UNITED STATES PATENT AND TRADEMARK OFFICE

APPLICATION NO.	FILING DATE	FIRST NAMED INVENTOR	ATTORNEY DOCKET NO.	CONFIRMATION NO.
10/614,354	07/07/2003	Thomas J. Sonderman	2000.100800	7900
23720	7590	06/21/2005	EXAMINER	
WILLIAMS, MORGAN & AMERSON, P.C. 10333 RICHMOND, SUITE 1100 HOUSTON, TX 77042			NGUYEN, KHIEM D	
			ART UNIT	PAPER NUMBER
			2823

Office Action Summary

DETAILED ACTION

FIG. 1
PRIOR ART

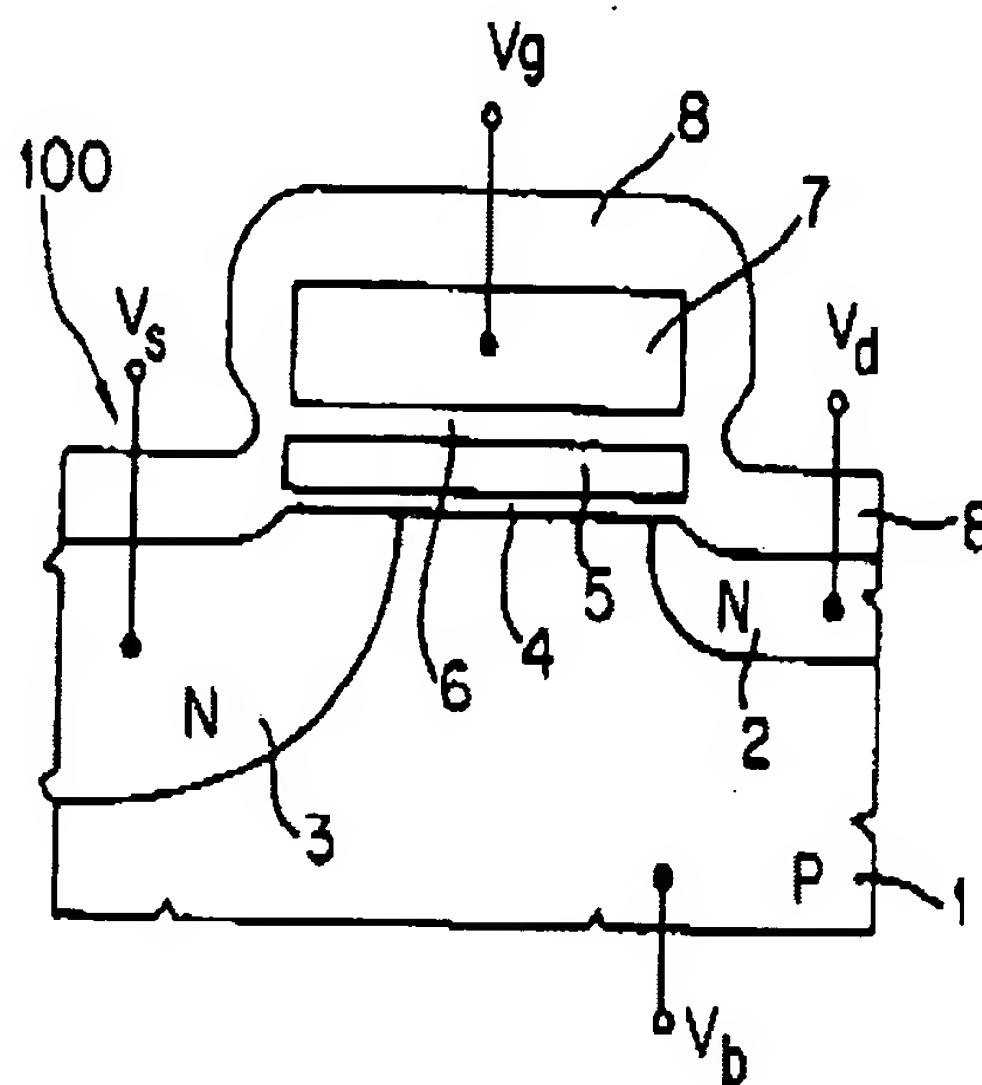
In re claim 12, Cappelletti discloses that the semiconductor device is comprised of a memory device that is comprised of a gate insulation layer 4, a floating gate layer 5 positioned above the gate insulation layer 4, an intermediate insulation layer 6 positioned above the floating gate layer 5, and a control gate layer 7 positioned above the intermediate insulation layer 6 (col. 1, lines 18-27 and FIG. 1).
